MINUTES
PLANNING COMMISSION MEETING
1300 NE Village Street
Fairview, OR 97024
Tuesday, July 10, 2018

a. Application 2018-21-DR-CUP: Proposed Mixed-Use Development Sandy Blvd.

2018-21-DR CUP
Fairview Villa

Planning Commission Staff Report

SITE ACCESS

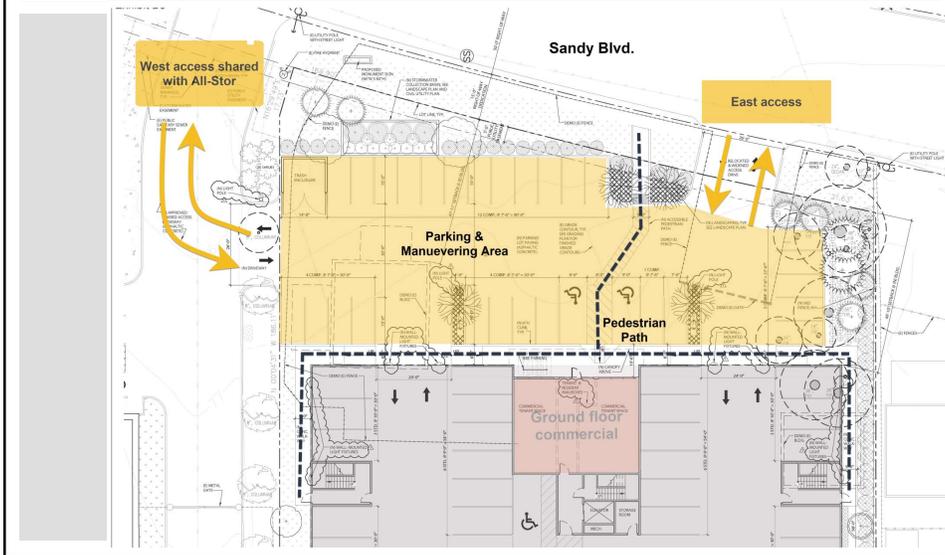
Conditional use permit to increase the building height; allowed limit is 45 feet, requesting 51 ft. 6 in. The Commission supported staff's recommendation of increasing the east side set back from 0 ft. to 15 ft.; current site plan has an 11 foot set back to mitigate the height transition between the development and adjacent property. Staff verified that the code does support this type of condition when requesting a height increase and this was included during the pre-application phase. The Commission indicated that staff's recommendation is reasonable and suitable for the increased height request. Chair Jones noted staff's recommendation for buffer trees (over 20 feet when mature) and the potential impact to the single level residences next door should be considered.

Vice Chair Williams noted concerns about there not being enough parking. In practice, Sandy Blvd. is not a minor arterial. Mr. Bick commented the proposal complies with the code for

parking; adequate on-site parking for residents is provided. He also noted the driveway is not a shared driveway with Quail Hallow MHP, but is in close proximity.

ON-SITE CIRCULATION

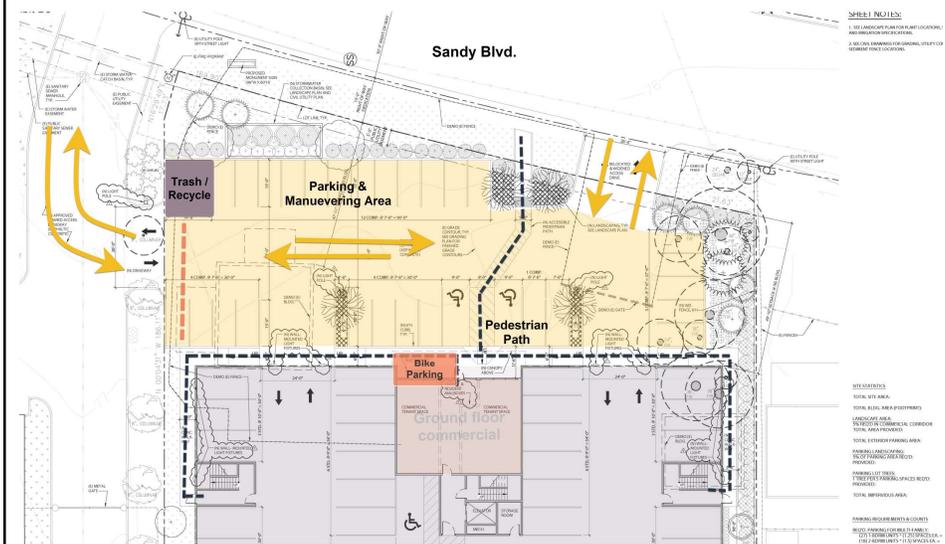
Location of pedestrian pathway and location of trash containers were noted. The Commission indicated support that the trash containers be relocated for safety and that pedestrian pathways meet the code and provide safe access from Sandy Blvd.

- C.5 Revise the site plan to provide a pedestrian walkway between the building perimeter and the trash enclosure
- D.3 The four trees identified as significant vegetation shall remain on site and be protected before, during and after construction. Should the arborist report find that any of the trees are diseased or dying, mitigation shall be proposed for city review in lieu of preservation.
- E.5 Relocate the 5 ft. wide pedestrian pathway to provide a pedestrian access from Sandy Blvd. at a 100 ft. maximum interval

LANDSCAPING

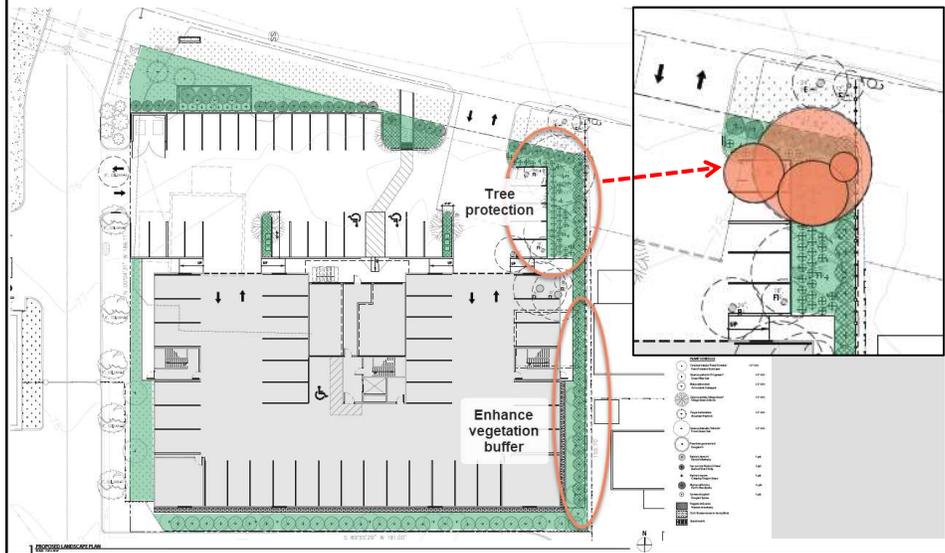
Preservation of significant trees. The Commission felt more of an effort was needed to show the significant trees on the property could not remain and the site plan adapted to keep the trees. Staff proposed the applicant retain an arborist to evaluate the trees and then determine the impact of preserving the trees may have on the site plan, parking, etc.

Commissioner Hook commented he would like the four significant trees to remain. If the hearing is continued he would like to see an arborist report providing information about the trees and a revised site design indicating the impacts of keeping them.

- C.3.a Revise the site plan to provide a 15 ft. setback from the east property line
- C.3.b Revise the east building elevation to add additional façade articulation, breaking up large expanses of flat wall planes through projections and recesses, along with variation in building material and color
- C.3.c Revise the landscape plan to add additional trees at regular spacing along the east side of the building to serve as a buffer between the taller proposed building and lower abutting residential development. Buffer trees shall reach a mature height of 20 ft.
